Revised STAFF REPORT AND RECOMMENDATION TO THE DESIGN COMMISSION

CASE FILE: LU 16-111127 DZM AD
PC # 15-229299
SW 3rd & Salmon
REVIEW BY: Design Commission
WHEN: June 16, 2016 @ 1:30pm
(Continued from May 5, 2016)
WHERE: 1900 SW Fourth Ave., Room 2500A
Portland, OR 97201

Proposal: The applicant proposes a new 20-story hotel building with an FAR of 11.7:1; the additional 2.7:1 FAR above the 9:1 base allowed is achieved via the locker room bonus (33.510.210.C.8). The building is proposed to feature ground level retail, with restaurants at both corners and a central lobby facing SW Salmon. A secondary entrance at SW 2nd would lead to a rooftop bar with rooftop terraces, including a shallow pool. One loading space is proposed at SW 2nd Avenue. Exterior materials include dark burgundy brick, warm gray metal panel, dark gray spandrel glass, and glass curtain wall. The proposal will require the demolition of the existing Albion Hotel (Lotus Cardroom & Café).

3RD & SALMON / PORTLAND, OR
C.50 ELEVATIONS - EAST - SW 2ND

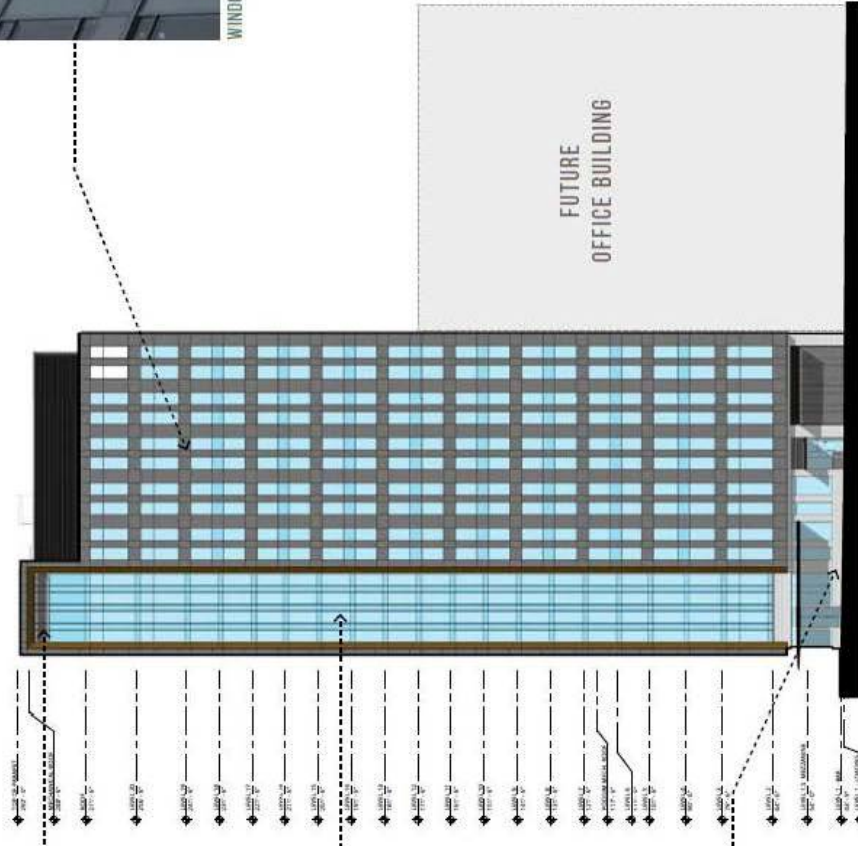
The applicant has also noted that the metal panel located at the base of the wall adjacent to the speakeasy entrance and the metal panel at the loading bay is also 18 gauge. Staff believes that the metal panel at the speakeasy entrance should be revised to brick in order to be more durable and more coherent. In addition, the metal panel at the loading bay should also be revised to a composite metal panel or steel in order to ensure durability.

- **The beveled bronze metal accents shall be composite metal;**
- **The east frame shall be closed on the bottom to match the condition on the west;**
- **8-inch deep fins shall be added to the east curtain wall, similar to the condition on the west, but for a greater length;**
- **The metal panel stem wall at the speakeasy entrance shall be revised to brick; and**
- **The metal panel at the loading bay shall be revised to composite metal panel or steel;**

Findings: No details were provided for the proposed signage, however it appears that the amount of proposed signage is within the total amount allowed and each sign appears to be less than 32 square feet, making them exempt from design review. Generally, signs are proposed to be typically located, above or at entrances, at corners, and at the parapet. Because the signs are all 32 square feet or much less, including the parapet sign, they will not dominate the skyline or the pedestrian experience. Staff suggests, however, that sign #2 be relocated to the north end of the window wall so that it does not disrupt the lantern feature.

With the condition of approval that sign #2 be relocated to the north end

- D. The beveled bronze metal accents shall be composite metal panel; the east frame shall be closed on the bottom to match the condition on the west; 8-inch deep fins shall be added to the east curtain wall, similar to the condition on the west, but for a greater length; the metal panel stem wall at the speakeasy entrance shall be revised to brick; and the metal panel at the loading bay shall be revised to composite metal panel or steel.
